VIA FEDERAL E-RULEMAKING PORTAL

October 25, 2023

**RE: Comments on Draft Environmental Impact Statement and Draft Management Plan for Proposed Chumash Heritage National Marine Sanctuary, NOAA-NOS-2021-0080**

**Figure 3: Proposed Ocean Space for cables landing at Morro Bay given Agency-Preferred Proposed Boundary, illustrating the limited width of ocean space outside sanctuaries**

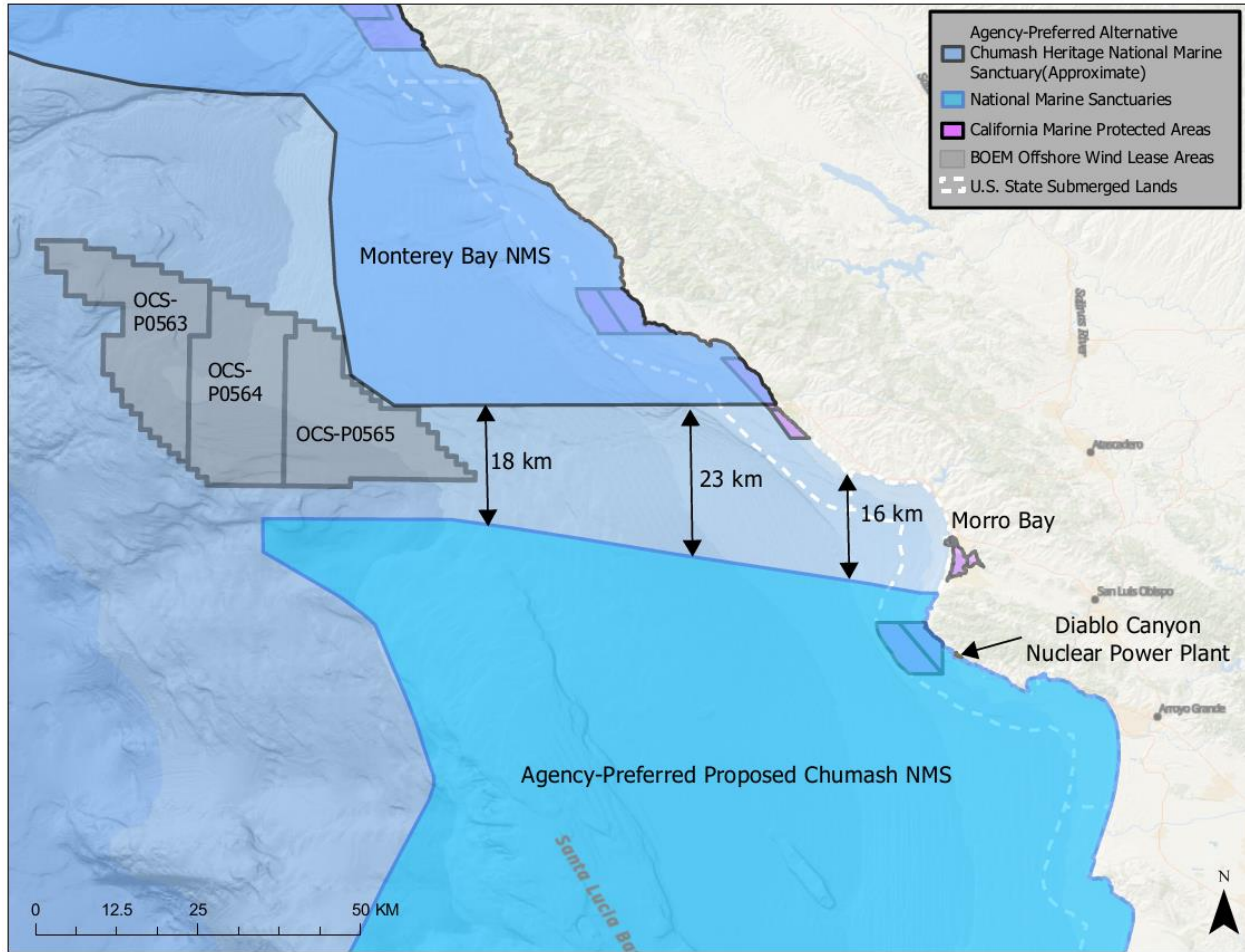
Off the Central California coast, within and adjacent to the Central California Lease Areas, the average water depths range from 900 to 1,300 meters. Significant water depths persist relatively close to shore, requiring significant physical cable spacing amongst export cables to allow for sufficient space to accommodate future cable repairs. Given industry standards for cable spacing, there may need to be areas offshore wider than 13-15 km *per lease area* to accommodate export cables. **Figure 3** depicts the amount of available ocean space between the southern boundary of the Monterey Bay NMS and the northern boundary of the Agency-Preferred Proposed Sanctuary

and highlights the insufficient proposed ocean space available to accommodate all three projects' submarine export cable systems.

**Figure 4: Map of initial Offshore Constraints that may affect submarine cable routing**

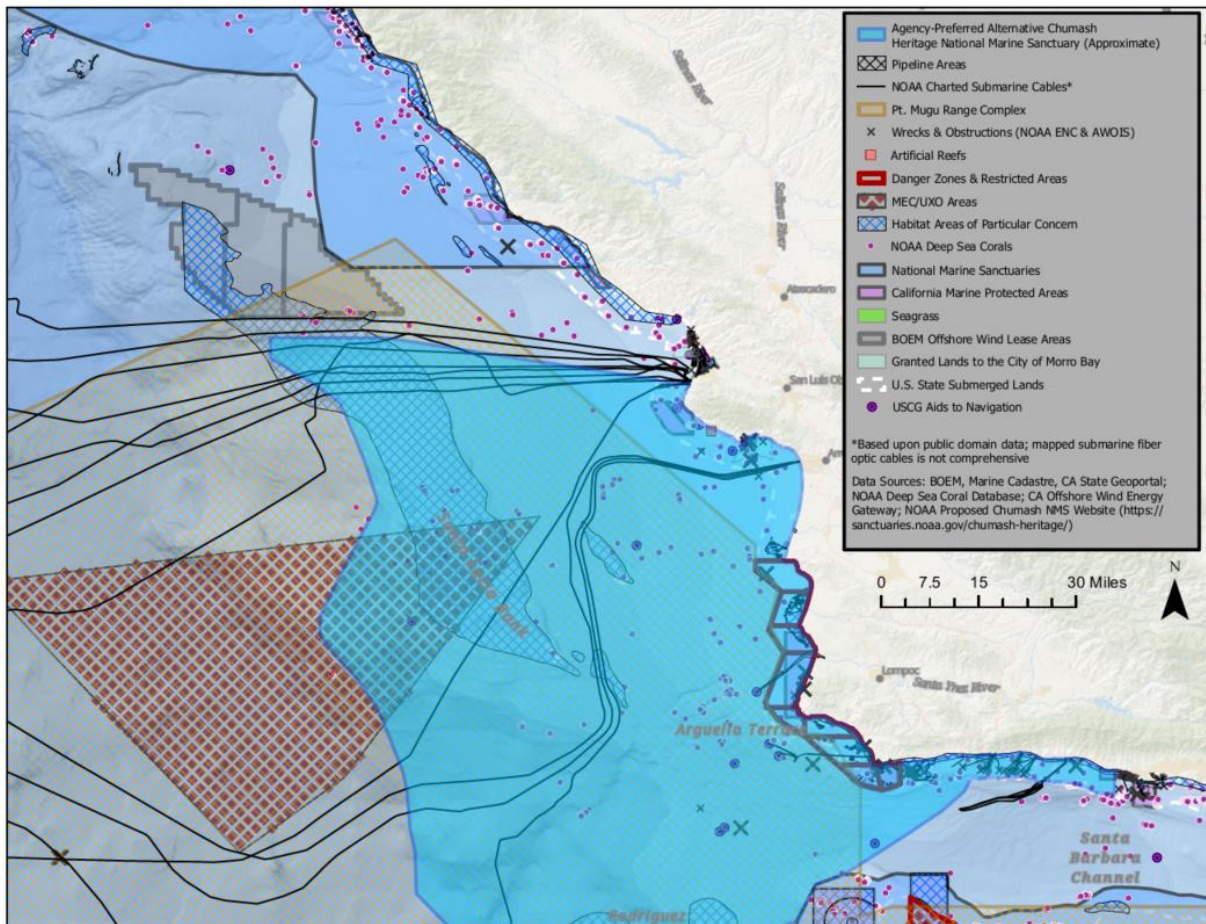
Based on our preliminary assessment, some of these potential constraints and existing uses include the following, which are depicted in **Figure 4** (please note this list is not exhaustive):

Given how nascent the Central California Lease Area projects are, it is premature to identify precise target POIs for the projects. As such, as discussed above, it is presumed, during this stage of project development, that two areas of focus for the Central California Lease Areas would be Morro Bay and Diablo Canyon. Given the numerous technical considerations with respect to submarine cable routing and marine resources and users in this area, as described above, flexibility

in submarine cable routing is imperative. Such flexibility will allow for the lowest-impact submarine cable routes to be developed, regardless of where the target landing locations are.
